Presidio Trust Management Plan
Main Post Update

Response to Comments

THE PRESIDIO TRUST
NOVEMBER 2010

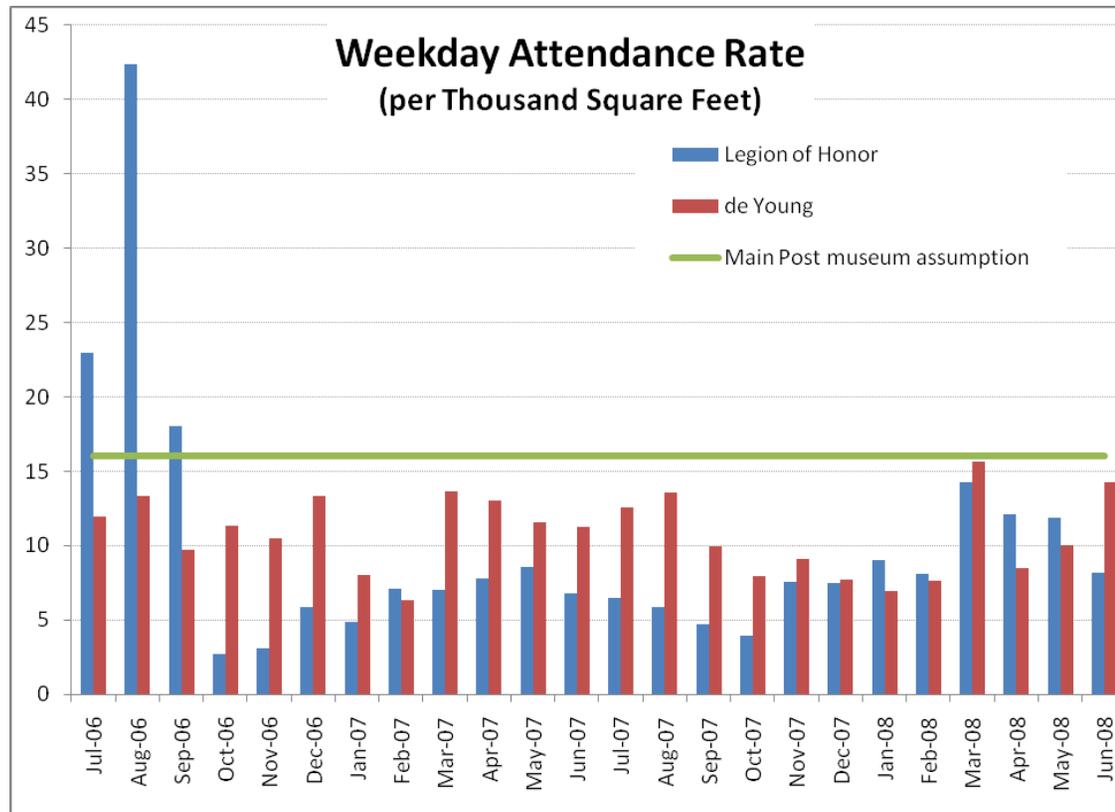
free days or extended hours. The method used in the traffic analysis to estimate daily and weekend traffic is based on annual estimates divided by days in the year. Peak traffic is estimated for weekday hours and weekend hours assuming all visitation and traffic is equally distributed by day and week throughout the year. The differences in monthly visitation are from 30 percent to 100 percent greater than the average. Daily peak traffic and weekend peak traffic are severely understated and should take into account these peak months.

Response The contemporary art museum proposal (CAMP) has been withdrawn. Traffic estimated for the CAMP (formerly part of

Alternative 2) and the History Center (Alternative 3) in the draft SEIS and final SEIS is not based on annual estimates divided by days in the year as asserted by the commentor. The weekday trip generation rate used for these projects reflects a typical peak day. A comparison of the assumed attendance rate (person round-trips per thousand square feet) for the History Center compared to average weekday attendance rates for the Legion of Honor and the de Young Museums by month over the past two years is provided below. The assumed trip generation rate for the History Center is 32.1 two-way (or 16.05 round-trip) person trips per thousand square feet, and is well above the average monthly weekday

attendance for these two museums, with the exception of attendance at the Monet exhibition at the Legion of Honor.

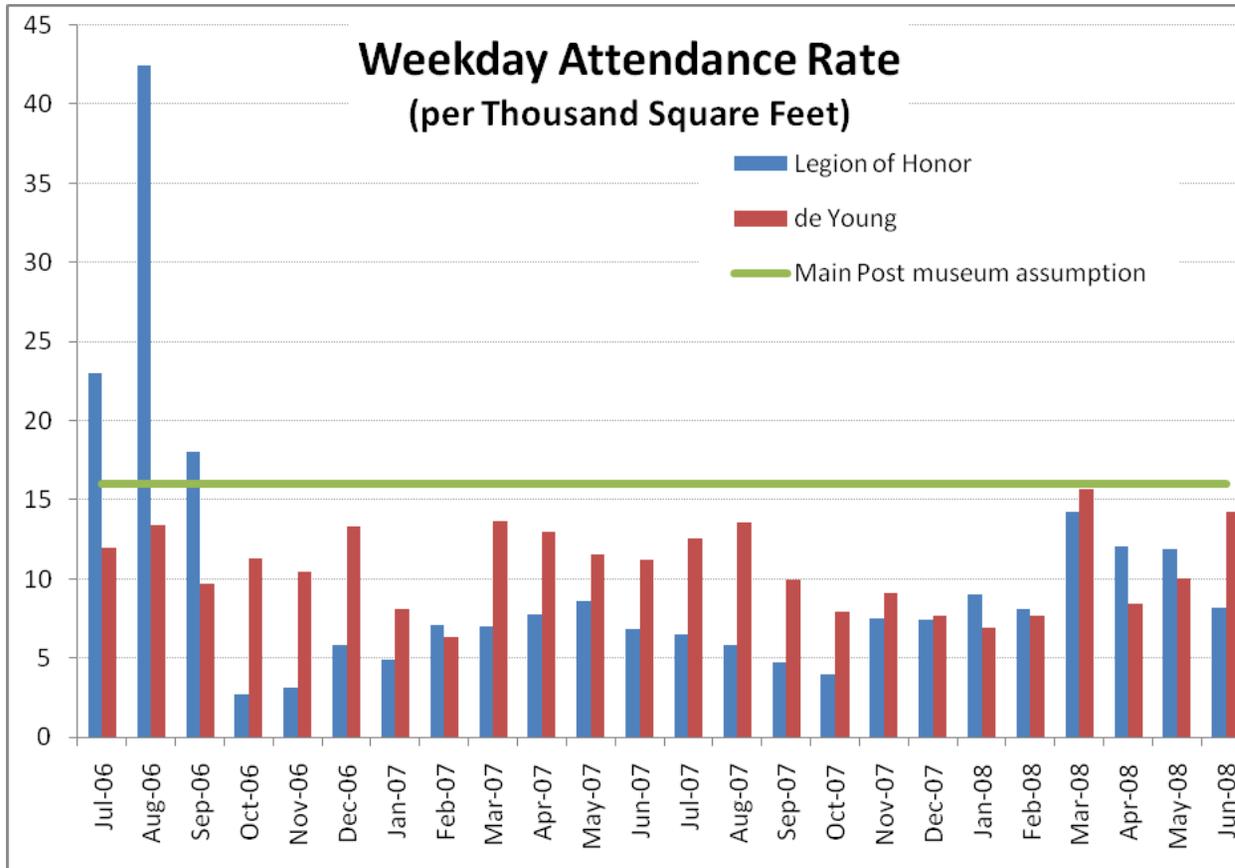
The visitation, traffic, and parking estimates do not take into account seasonal variations in attendance at the Main Post buildings. The CAMP estimates are too low, while several of the other building estimates appear unsupported or too high.

Response All visitation estimates are estimates of the total number of visitors each year. Average annual daily visitation was also calculated for each alternative, but only for the purposes of comparison among alternatives. The calculated average annual daily visitation was not used in any analysis, and to eliminate confusion about its intended purpose, the average annual daily visitation estimate has been deleted from the final SEIS.

The visitation estimates for the CAMP (formerly part of Alternative 2) and History Center (Alternative 3) were those provided by the project applicants in their respective proposals. These visitation estimates were checked against the annual visitation per thousand square feet from at the de Young Museum. The de Young Museum is approximately 300,000 square feet (in floor area) and attracted between 1.1 and 1.2 million visitors in 2007, for a derived annual visitation rate of 3.6 to 4 annual visitors per thousand square feet of floor area. The proposed 100,000-square-foot (gross exterior square footage) museum of contemporary art was assumed to attract 300,000 to 400,000 visitors per year and the 50,000-square-foot (gross exterior square footage) History Center was assumed to attract 150,000 visitors per year. These visitation estimates are generally consistent with the rates derived from the de Young Museum. Since the visitation estimates are on an annual basis and they were checked against annual visitation to the de Young Museum, the estimates include day-to-day variability and seasonal peaks in attendance.

Traffic estimated for the CAMP (formerly part of Alternative 2) and the History Center (Alternative 3) in the draft SEIS and final SEIS is not based on annual estimates divided by days in the year, as asserted by the commenter. The weekday trip generation rate used for these projects reflects a typical peak day. The chart below provides a comparison of the assumed attendance rate (person round-trips per thousand square feet) for the history center compared to average weekday attendance rates for the Legion of Honor and the de Young Museum by month over the past two years. The assumed trip generation rate for the history center is 32.1 two-way (or 16.05 round-trip) person trips per thousand square feet, and is well above the average monthly weekday attendance for these two museums, with the exception of the Monet exhibition at the Legion of Honor.
